INFORMATION BULLETIN LOG
CUSTOMER SERVICE

PERQPRODUCT PERQBULLETIN NO. 001SUB-ASSEMBLY MOTHER BOARD/IO BOARD

PART NO. MOM-001/IOB-001MODIFICATIONS FOR LASER PRINTER
OPERATIONSERIAL NO. ALL

LASER MODS

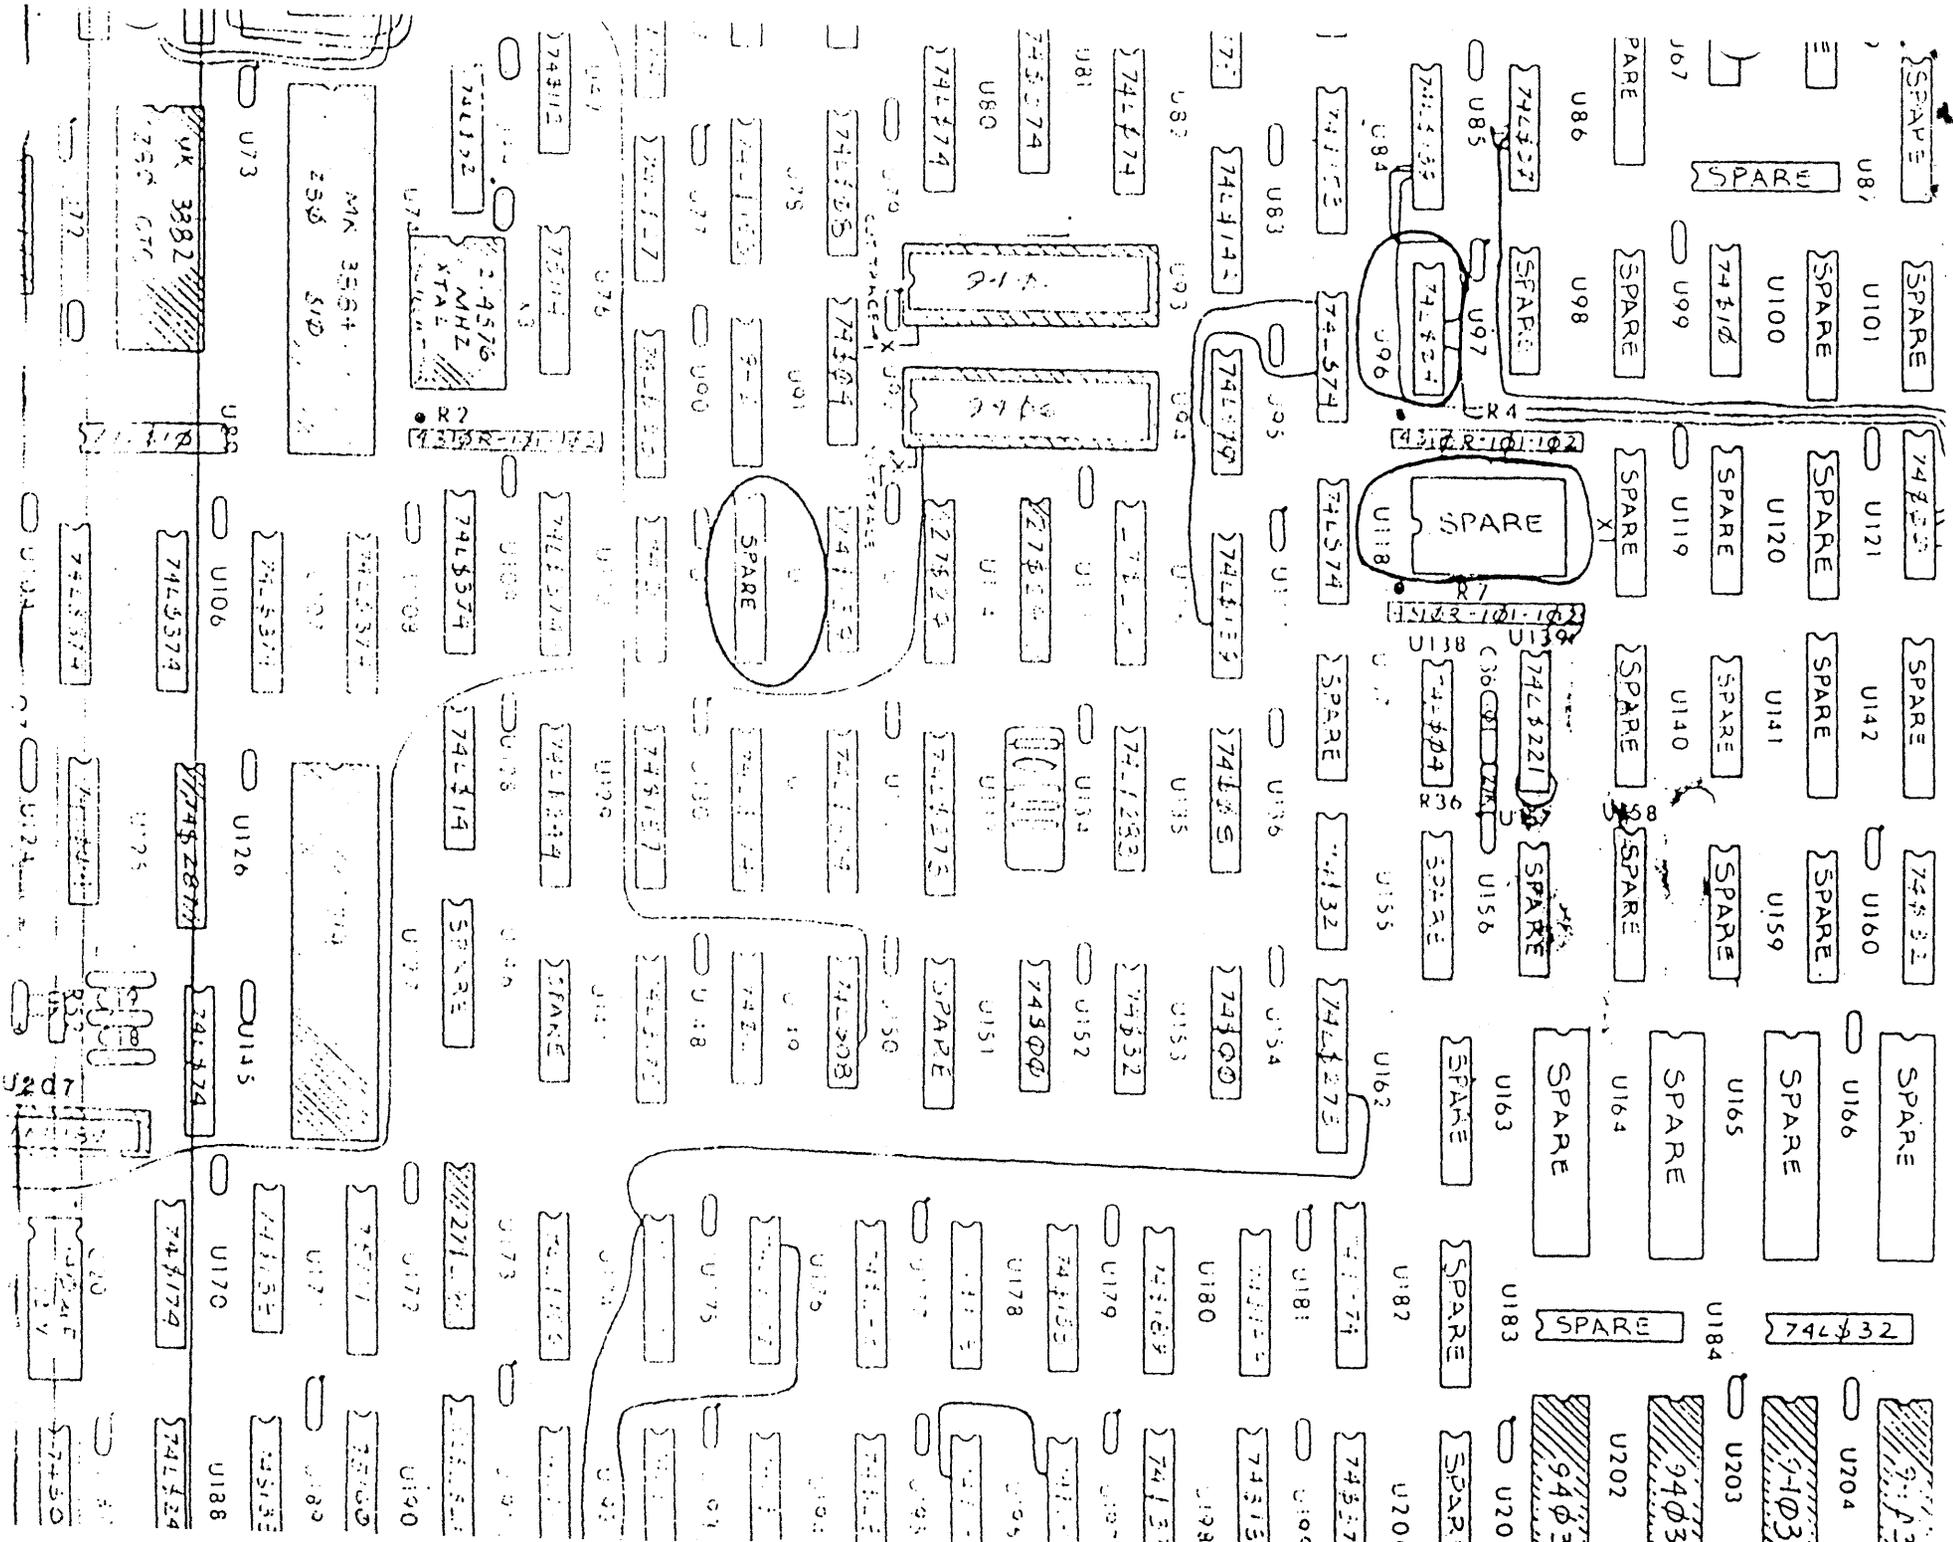
1. Verify that there is continuity between the backplane pins as reflected on the attached drawings.
If the wiring is missing, add the wire utilizing 30 gauge wire-wrap wire.
2. Remove IC U112 from the IOB-001 Board by cutting the chip out with a pair of miniature cutters. (See attached drawing).
(NOTE: On later revision IOB-001 Boards this IC will already be removed).
3. Add 470 ohm, $\frac{1}{4}$ watt resistors as follows:
 - a. From pin 2 to pin 7 of U118.
 - b. From pin 12 to pin 7 of U118.
 - c. From pin 2 to pin 7 of U96.
 - d. Ensure that pin 2 and pin 12 of U118 and pin 2 of U96 are not connected to ground.

Step 3: Add 470 ohm resistors:

- a. From pin 2 to Pin 7 of U118
- b. From pin 12 to pin 7 of U118
- c. From pin 2 to pin 7 of U96

Ensure that pin 2 and pin 12 of U118 and pin 2 of U96 are not connected to ground.

ETHERNET MODS

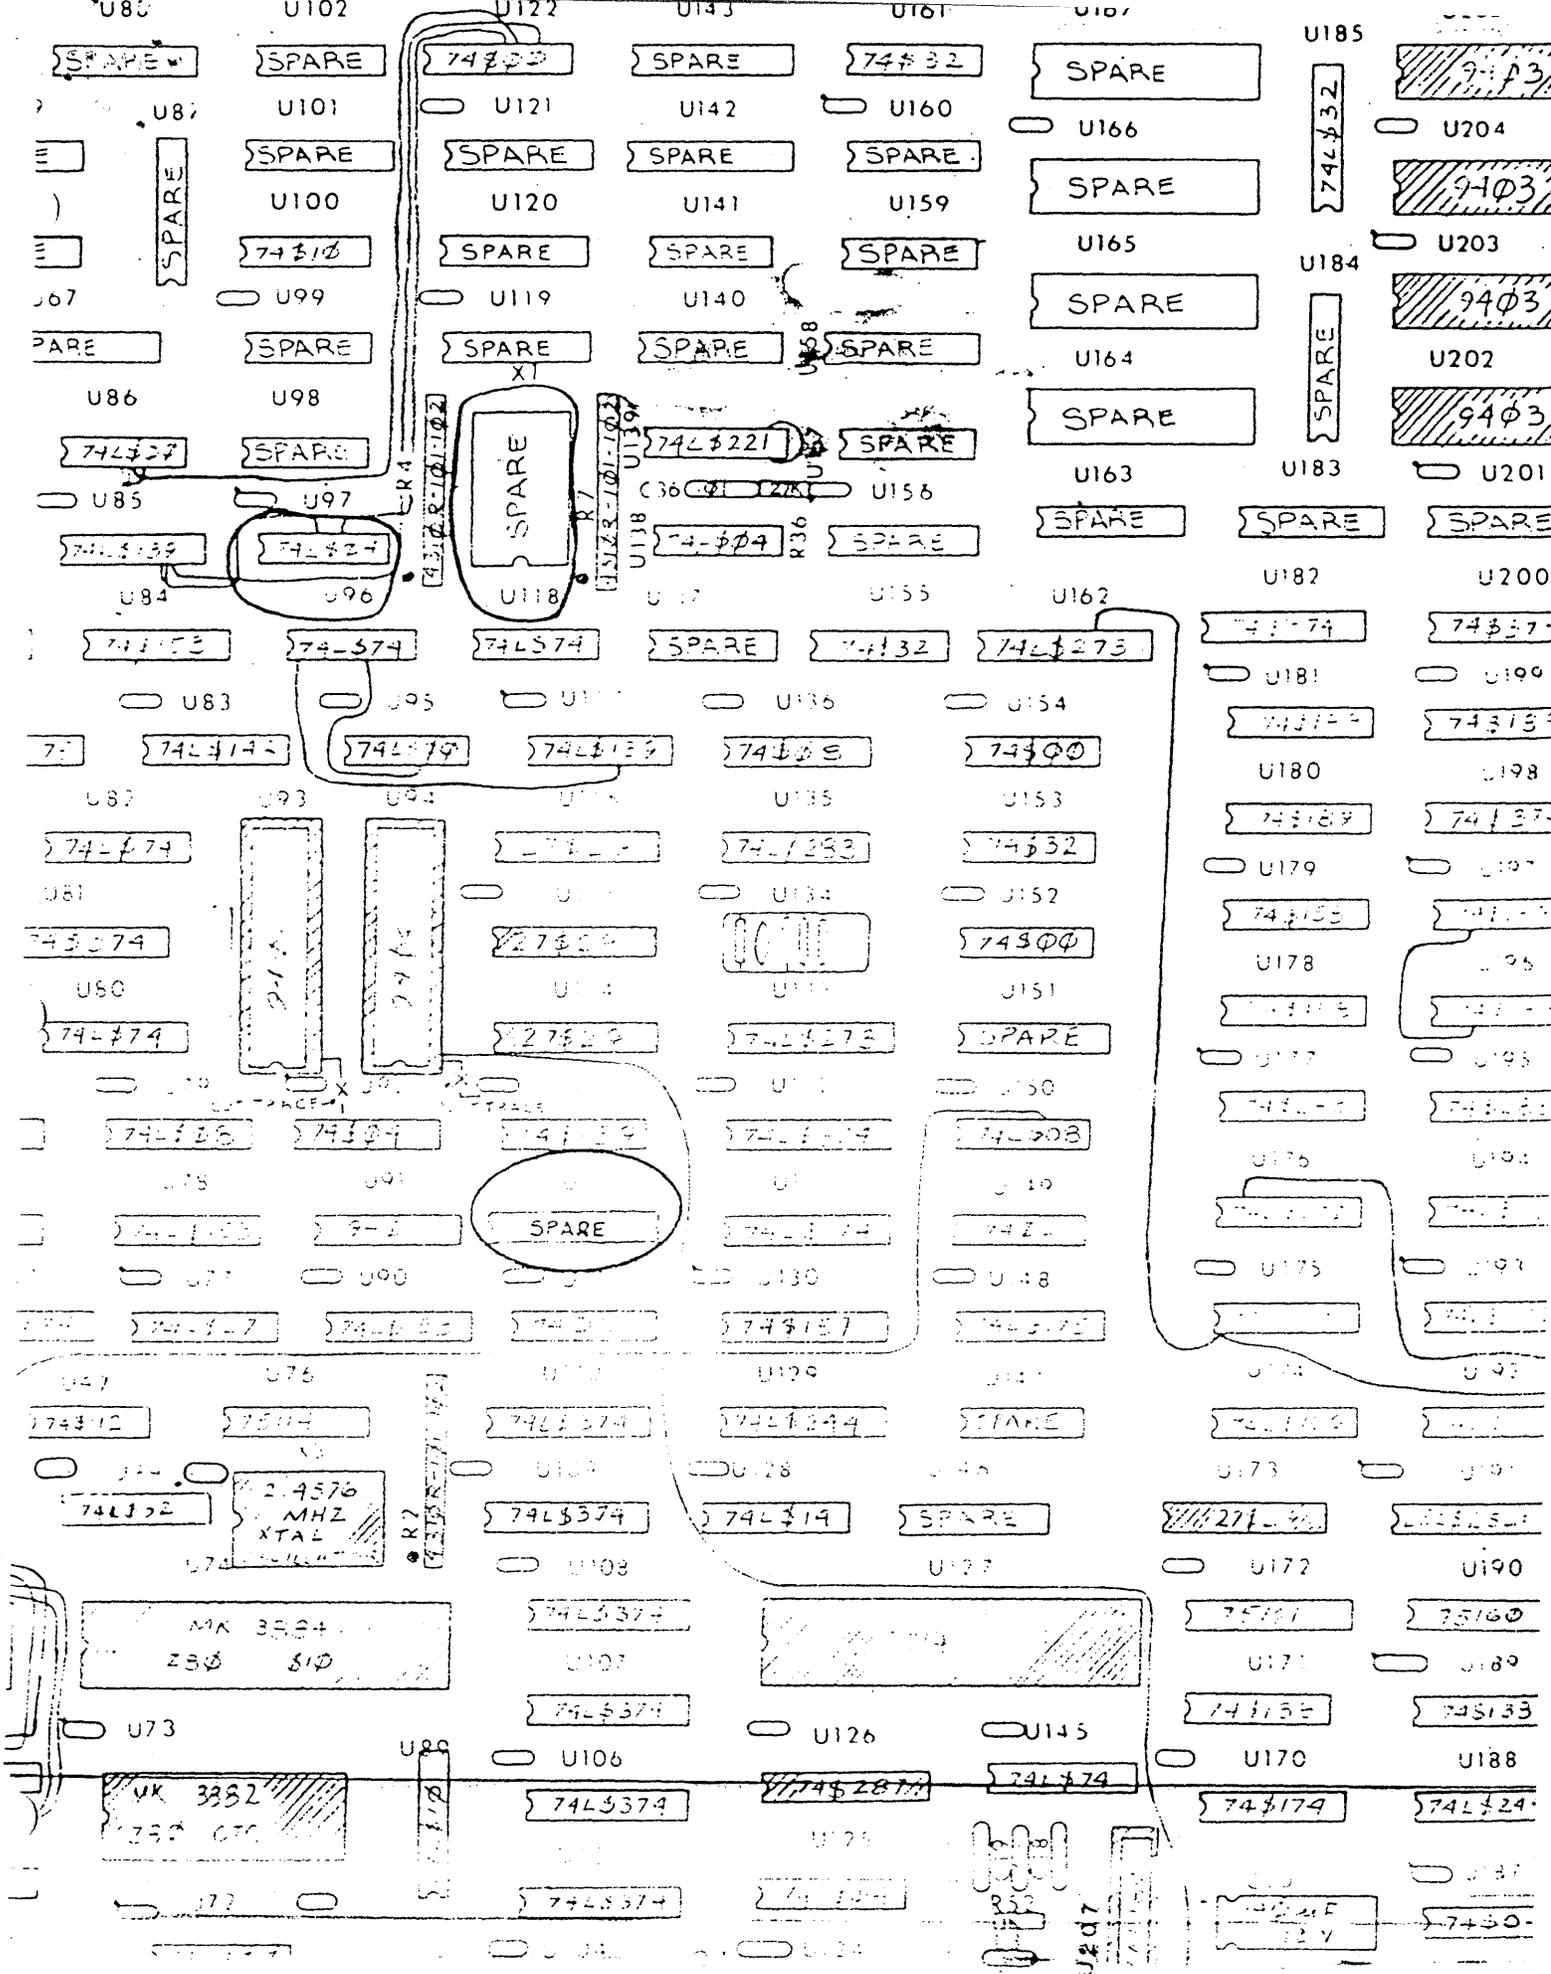
1. Verify that there is continuity between the backplane pins as reflected on the attached drawings.
If the wiring is missing, make the appropriate adds utilizing 30 gauge wire-wrap wire.
2. Remove IC U112 from the IOB-001 Board by cutting the chip out with a pair of miniature cutters. (See attached drawing).
(NOTE: On later revision IOB-001 Boards, this chip will already be removed.)
3. Add a 470 ohm, 1/4 Watt resistor as follows:
 - a. From pin 2 to pin 7 of U118.
 - b. From pin 12 to pin 7 of U118.
 - c. From pin 2 to pin 7 of U96.
 - d. Ensure that pin 2 and pin 12 of U118 and pin 2 of U96 are not connected to ground.

Step 3: Add 470 ohm resistors:

- a. From pin 2 to pin 7 of U118.
- b. From pin 12 to pin 7 of U118.
- c. From pin 2 to pin 7 of U96.

Ensure that pin 2 and pin 12 of U118 and pin 2 of U96 are not connected to ground.

TITLE DETAILED ECO WORK
OF ECO * 00066

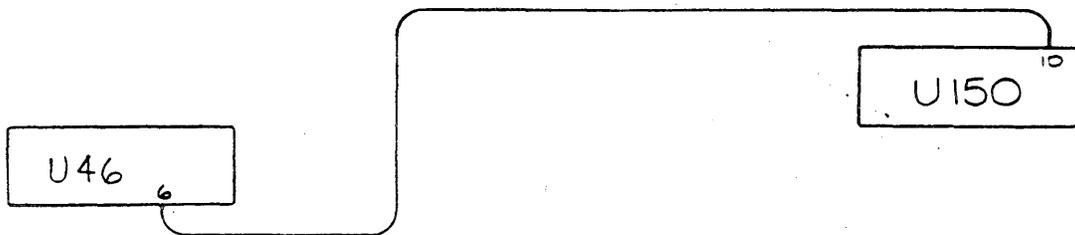
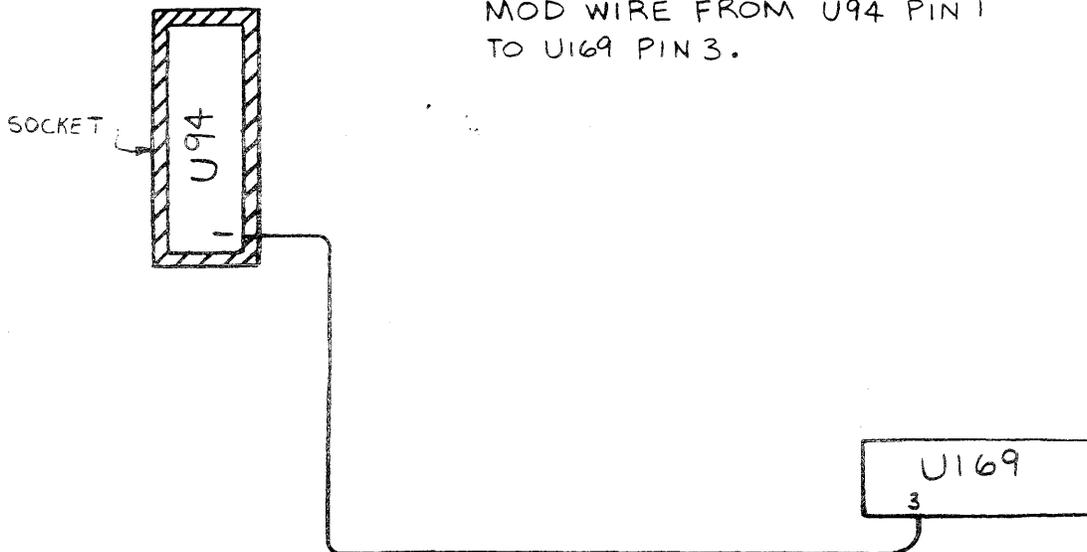
MOD WIRE FROM U46 PIN 6
TO U150 PIN 10.

MOD WIRE FROM U72 PIN 6
TO U169 PIN 3.

MOD WIRE FROM U94 PIN 1
TO U169 PIN 3.

1. Cut trace that goes from U93, pin 1, to U46, pin 6 on the component side of the board.
2. Cut trace that goes from U93, pin 1, to U150, pin 10.
 - a. "G" boards component side.
 - b. "F" boards non-component side.
3. Cut trace that goes from U169, pin 3 to U150, pin 10.

1. Add a mod wire from U46, pin 6 to U150, pin 10.
2. Add a mod wire from U72, pin 6 to U169, pin 3.
3. Add a mod wire from U112, pin 10 to U112, pin 18.
(The IC will not be present and you will actually be connecting pin 10 to pin 18).

TITLE DETAILED ECO WORK OF ECO # 00066

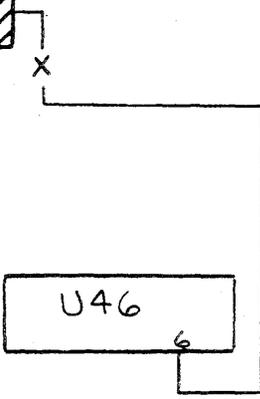
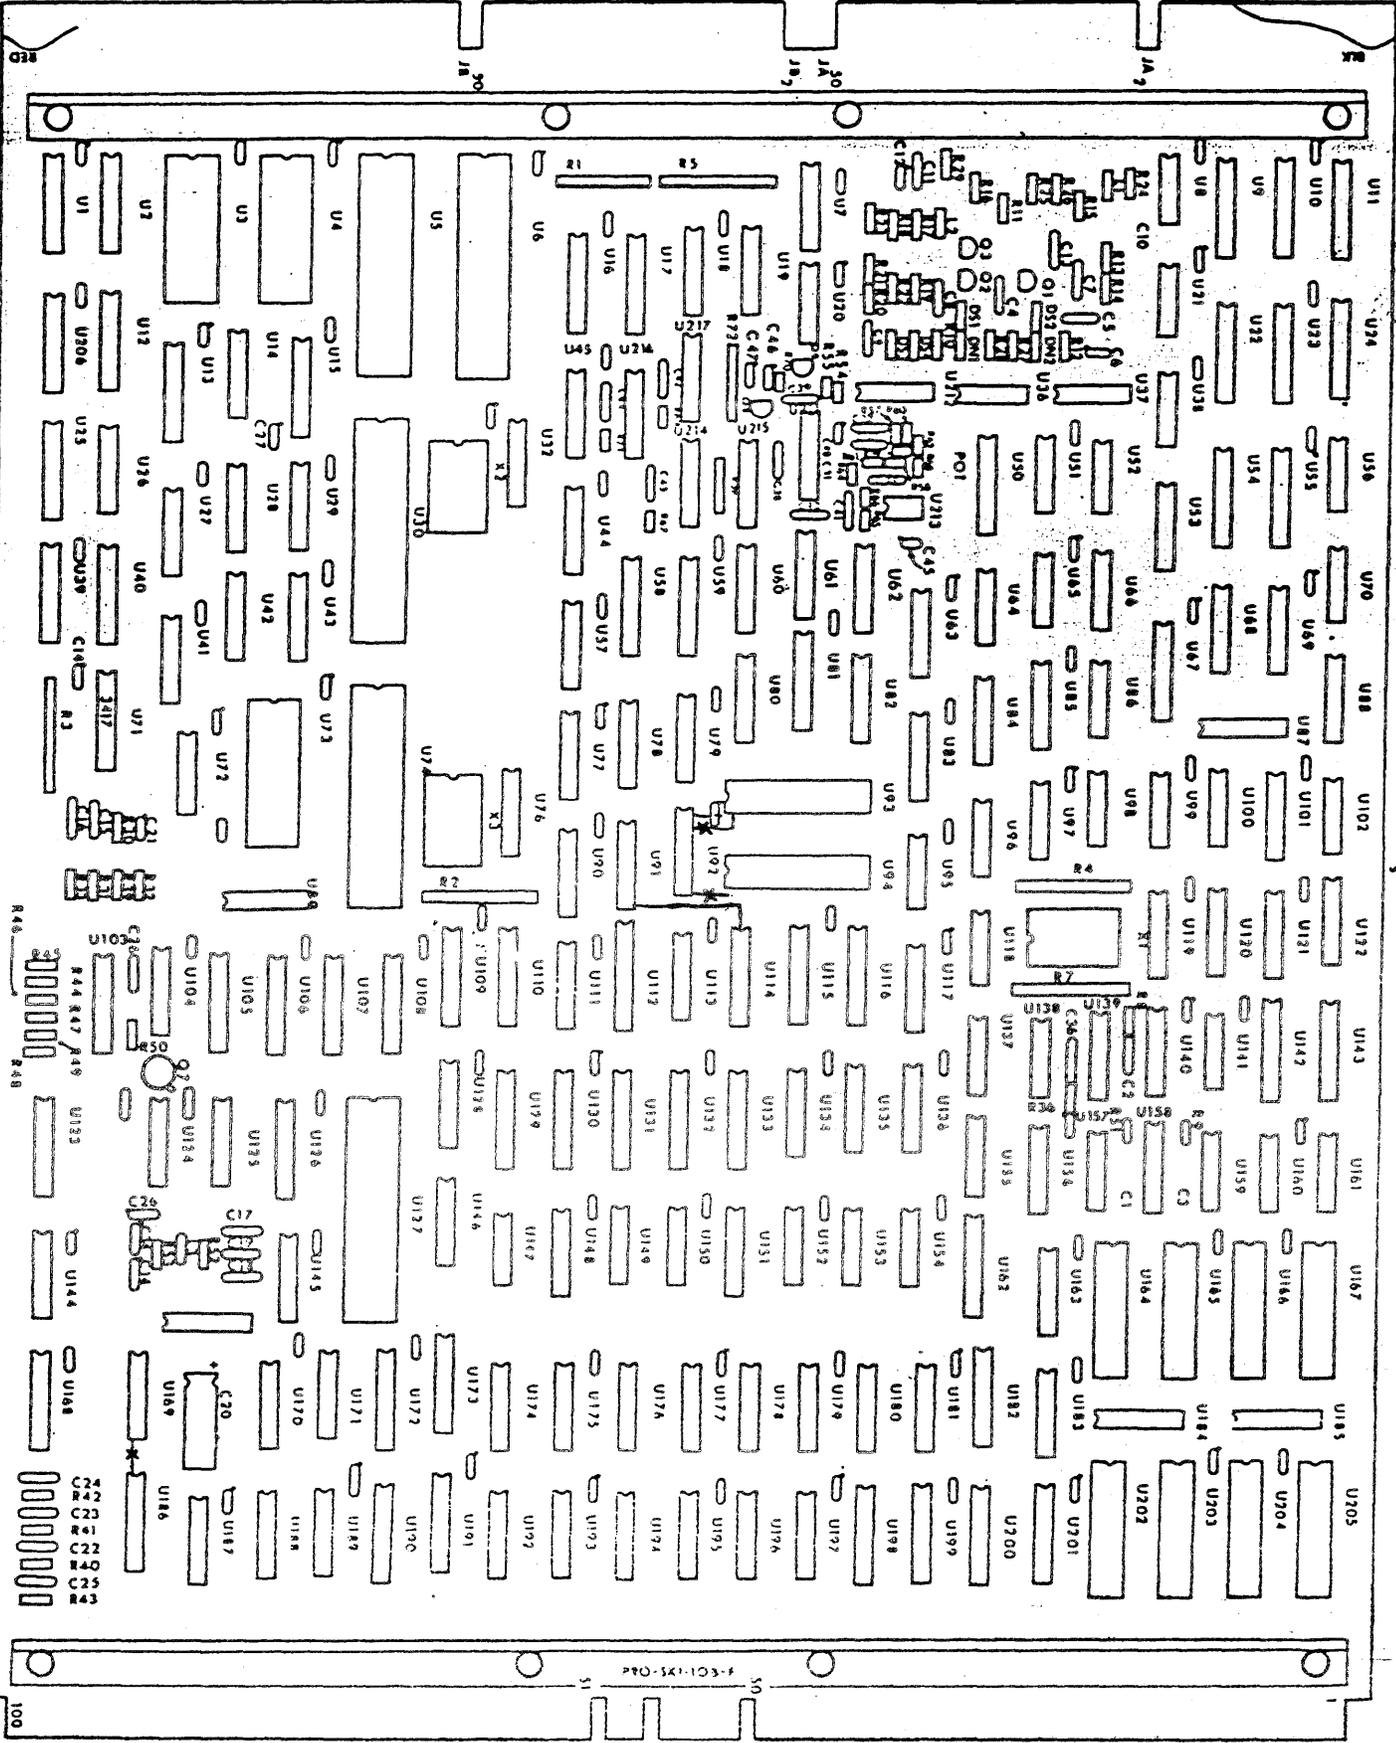
CUT TRACE THAT GOES FROM U93, PIN 1, TO U46, PIN 6. CUT TRACE CLOSE TO U93.

CUT TRACE THAT GOES FROM U94, PIN 1, TO U150, PIN 10. CUT TRACE CLOSE TO U94

CUT TRACE THAT GOES FROM U169, PIN 3, TO U150, PIN 10. CUT TRACE CLOSE TO U169.

NOTE
MAKE CUT FOR 10B-F BOARD, ON SOLDER SIDE. MAKE CUT FOR 10B-G BOARD, ON COMPONENT SIDE OF BOARD.

BULLETIN 5 - Under deletes, Paragraph 2, reads as follows: "Cut trace that goes from U93, Pin 1 to U150, Pin 10". Should read: "Cut trace that goes from U94, Pin 1 to U150, Pin 10".
